**AGENDA  
CITY OF CEDAR FALLS, IOWA  
PLANNING AND ZONING COMMISSION MEETING  
WEDNESDAY, JULY 28, 2021  
5:30 PM AT CITY HALL AND VIA VIDEO CONFERENCE**

**TO:** Planning & Zoning Commission  
**FROM:** Thom Weintraut, AICP, Planner III  
**DATE:** July 22, 2022  
**SUBJECT:** Land Use Map Amendment (LU21-01)  
 Rezoning Thunder Ridge, West 1<sup>st</sup> Street and Eagle Ridge Road (RZ20-009)

**TO:** Planning and Zoning Commission  
**FROM:** Jaydevsinh Atodaria (JD), City Planner I  
**DATE:** July 22, 2021  
**SUBJECT:** Property improvements in the College Hill Neighborhood Overlay District

Thunder Ridge Rezoning Plat  
PC-2, Planned Commercial  
Cedar Falls, Iowa

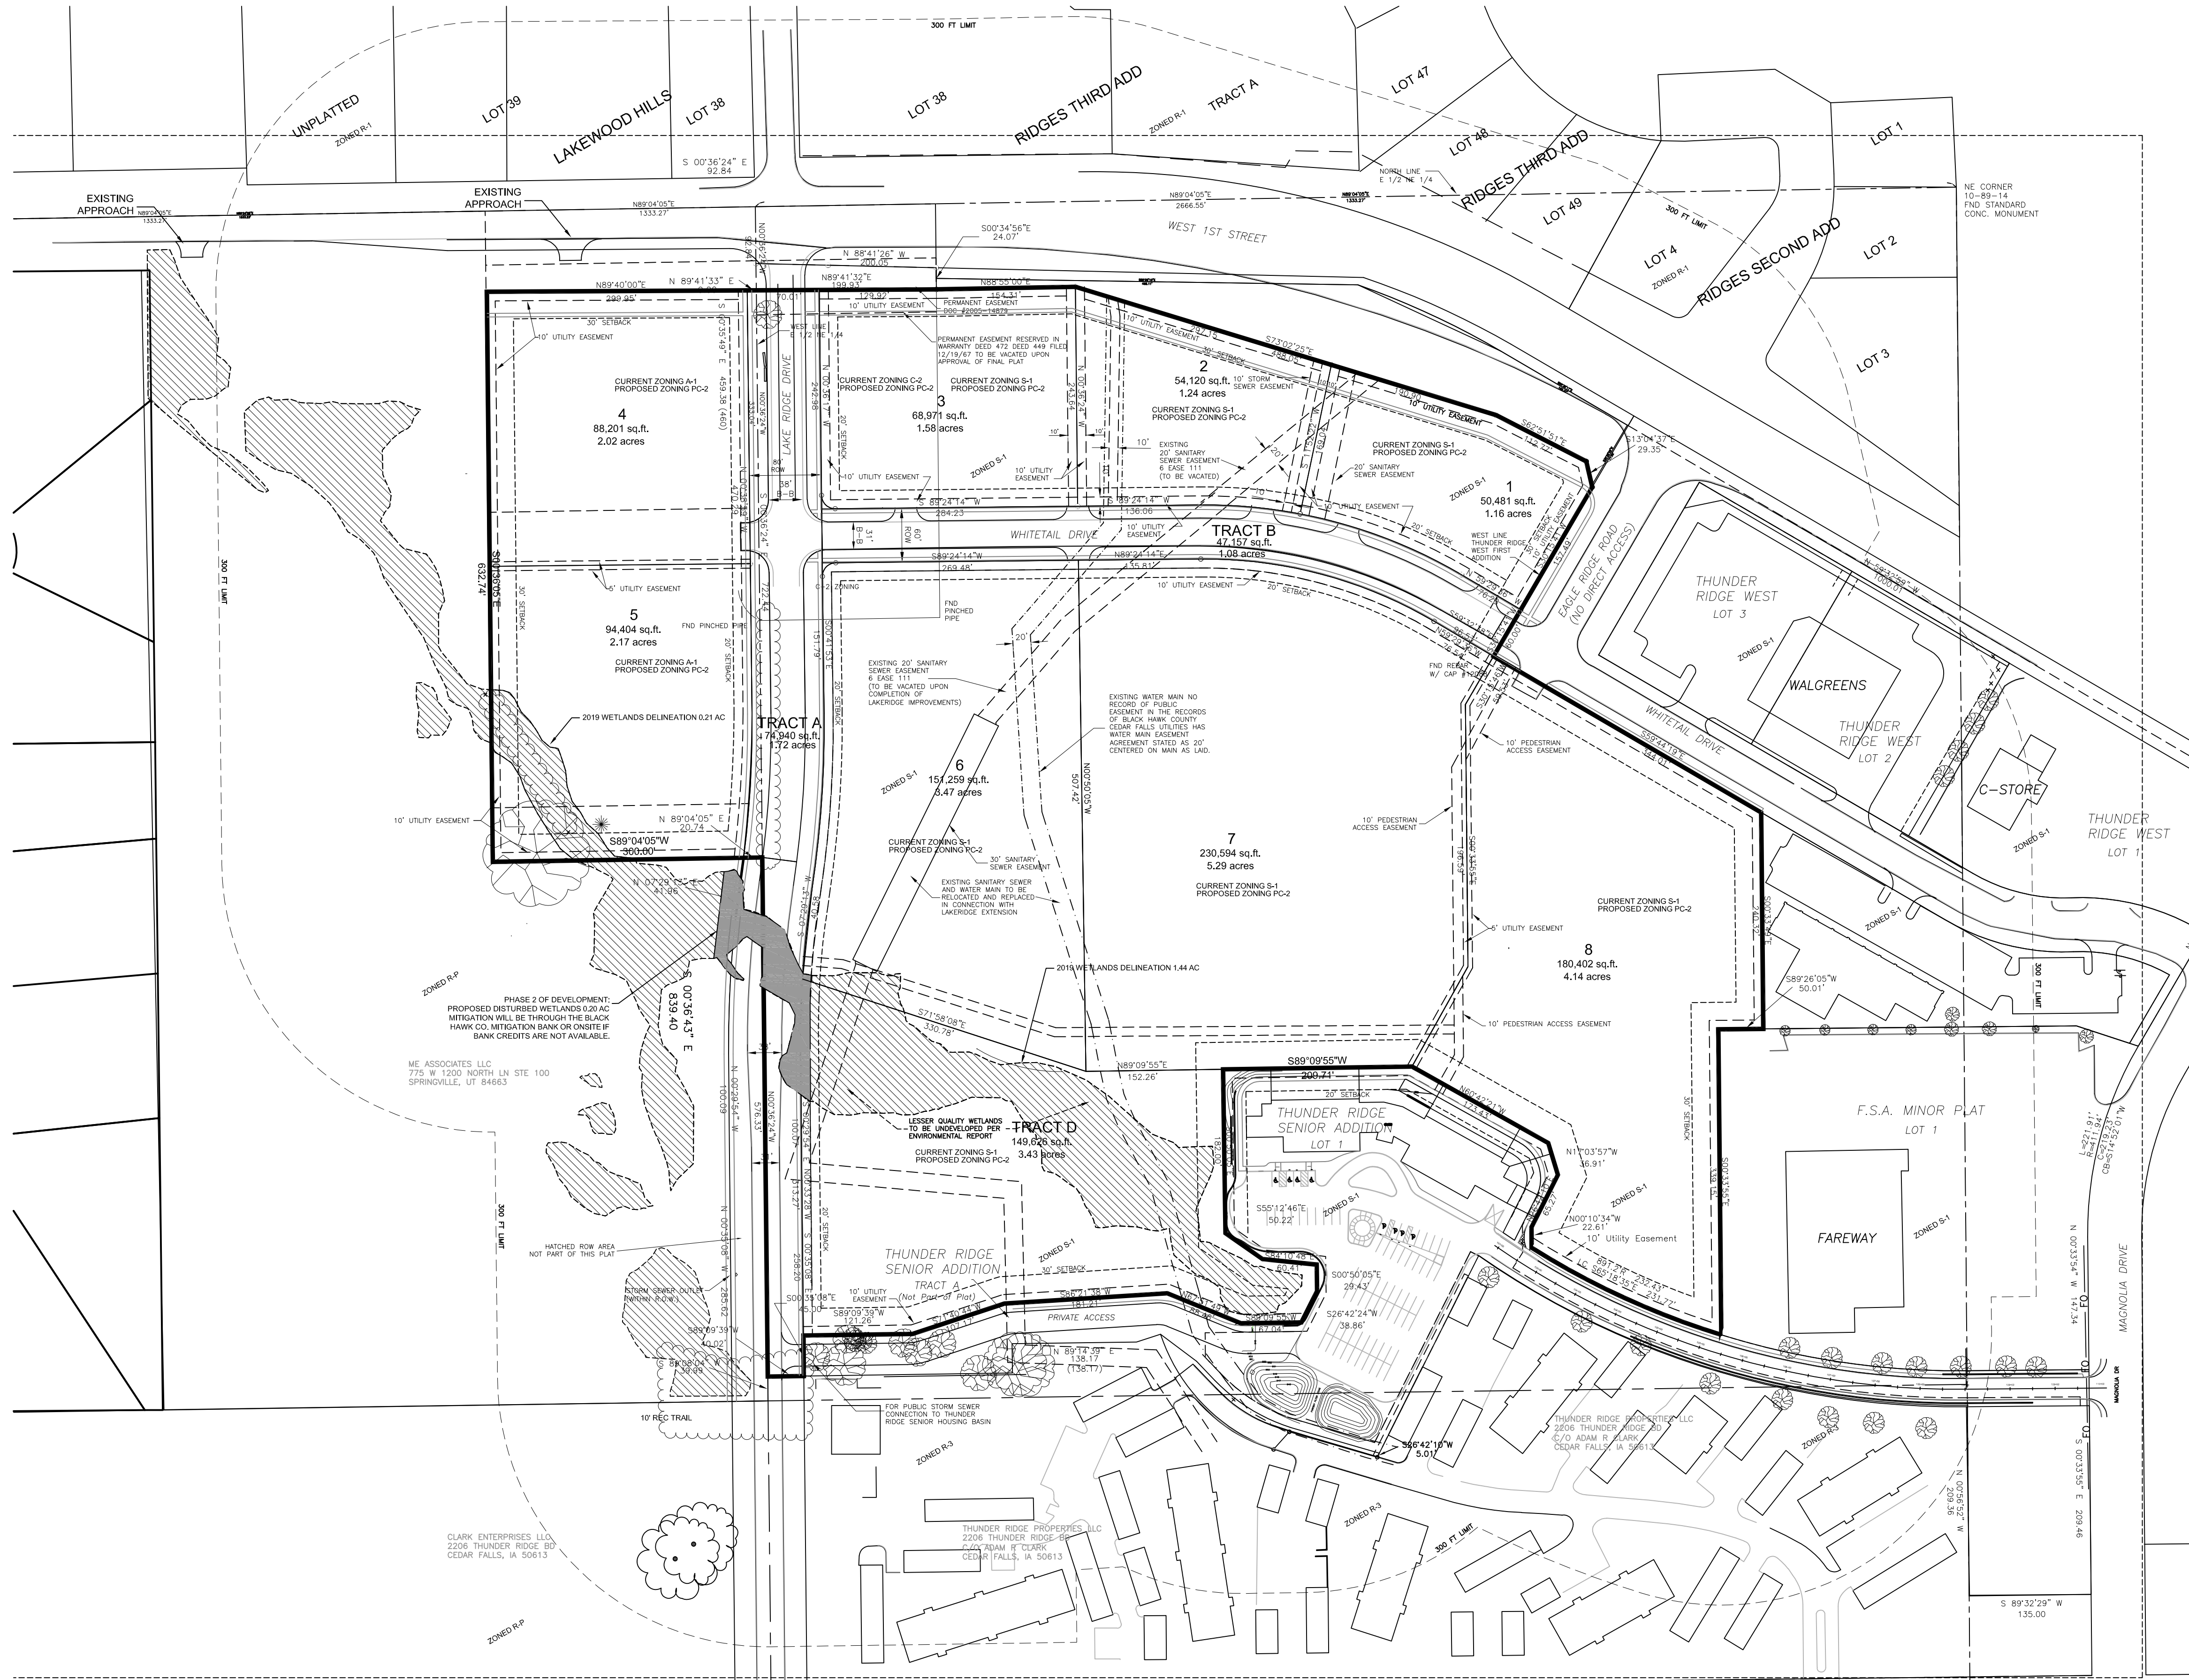
Since the last Planning and Zoning Commission meeting, the applicant has provided an updated Phasing and Landscape Plan and a updated Rezoning Plat showing sidewalks along W 1<sup>st</sup> Street. They have indicated the Land Use Plan, created by Emergent Architecture, will also be updated to reflect the 1<sup>st</sup> Street sidewalk. Staff also recommends that Emergent update the plan to match the Design Guidelines or simply remove the building and parking lot layouts from the plan to make it clear that the design guidelines must be followed when individual sites are developed. If the submitted master plan and development guidelines conflict, it is unclear how sites should be developed. The documents must be cleaned up to be internally consistent prior to approval.

THUNDER RIDGE REZONING  
PC-2, PLANNED COMMERCIAL  
CITY OF CEDAR FALLS, IOWA  
DEVELOPMENT PHASING PLAN

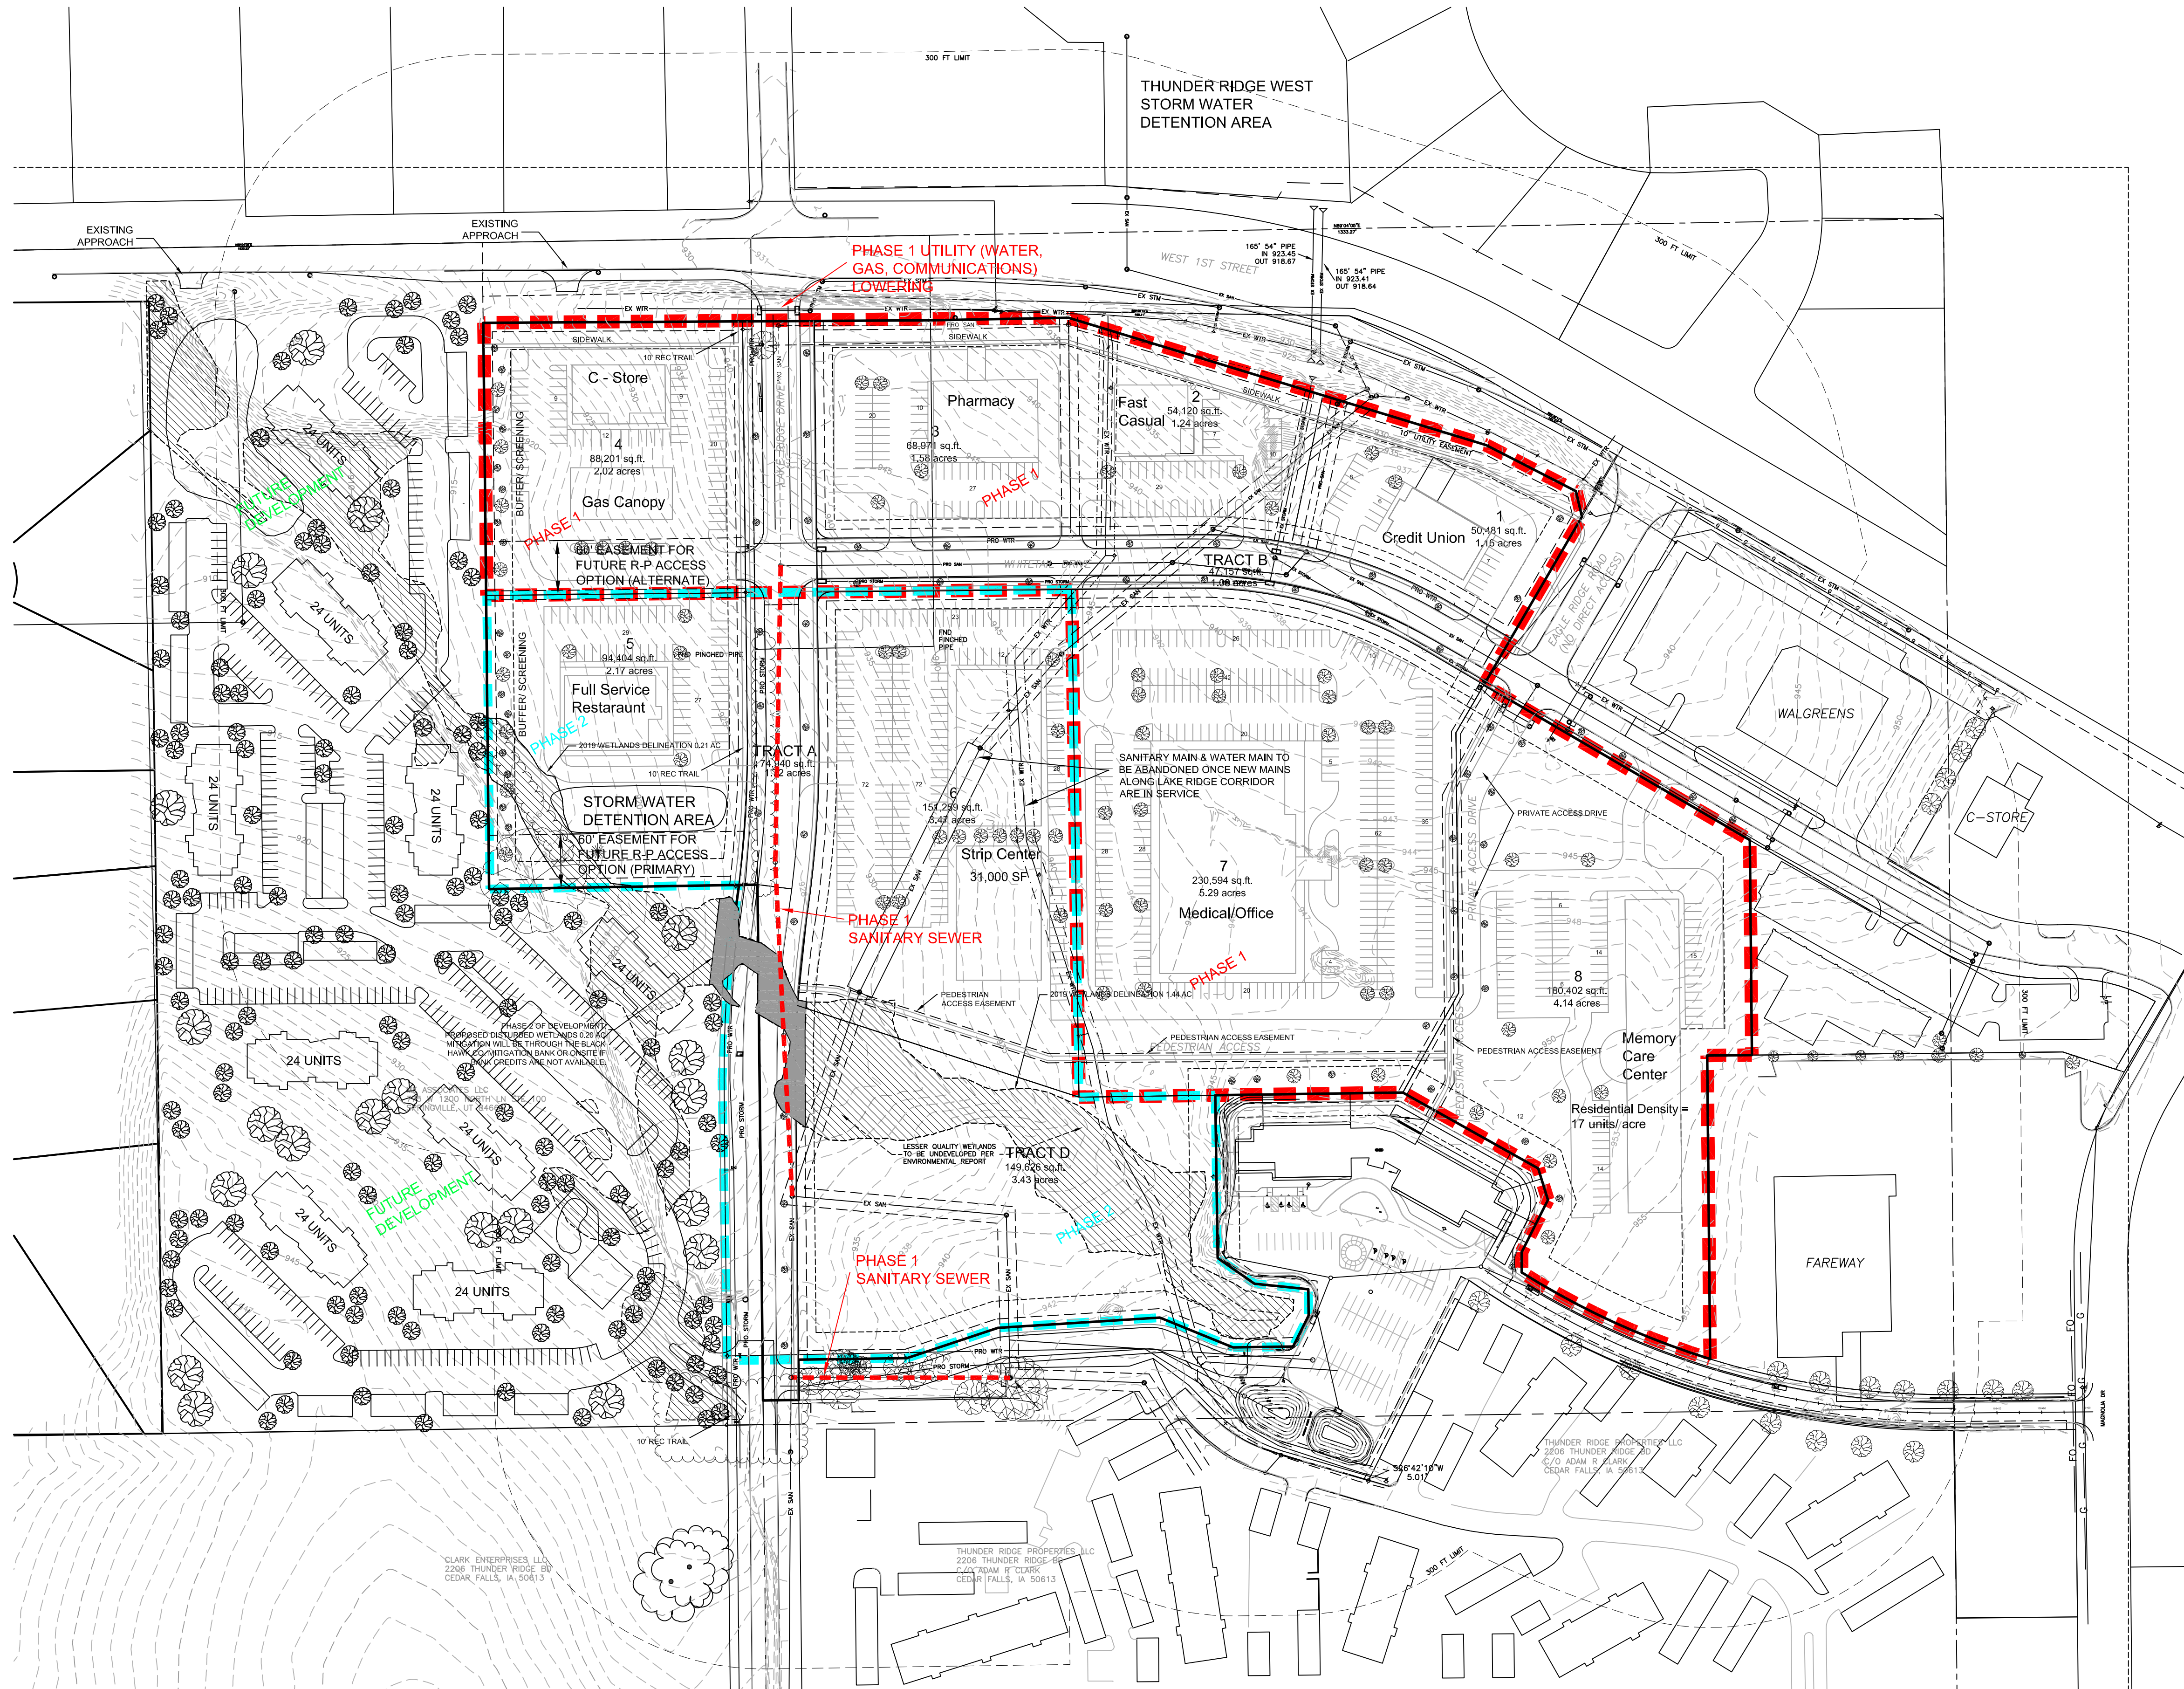
Staff acknowledges the desire of the applicant to develop the site in more than one phase, so that revenue can be generated to pay for the installation of the infrastructure. However, with so little development included in Phase 2, staff finds that there will be little incentive to extend Lake Ridge Drive to the south boundary of the development, leaving the future of this critical street connection uncertain. Staff suggests as an equitable solution amending the phasing plan to allow five (5) lots to be platted as part of Phase 1 and including lot 7, the medical/office lot, with Phase 2, creating more incentive to complete this street connection.

2. The development phasing plan does not meet the subdivision requirement to ensure timely connections of critical infrastructure. In this case, the extension of Lake Ridge Drive. Staff does not recommend approval until the phasing plan is amended to provide more certainty that this critical street will be extended.

As with any major development there is a considerable amount of infrastructure that must be installed. The phasing plan should be established to ensure that all the critical infrastructure is installed. In this case, the proposed phasing should be established in a manner that will ensure that the critical extension of Lake Ridge Drive is completed to the south boundary of the site. With so little development proposed in the second phase, there will be little incentive to construct the remainder of Lake Ridge Drive. To avoid similar mistakes that have been made in the past, the City recently amended the subdivision code to ensure that these issues are at the forefront when new development is proposed. Now is the time to address this issue. Staff recommends that the phasing plan be amended to more evenly divide the development between the two phases, so that there is incentive to develop the second phase and extend the street to the south boundary of the site. Alternatively, the entirety of the Lake Ridge Drive extension should be installed with the 1<sup>st</sup> phase of development.
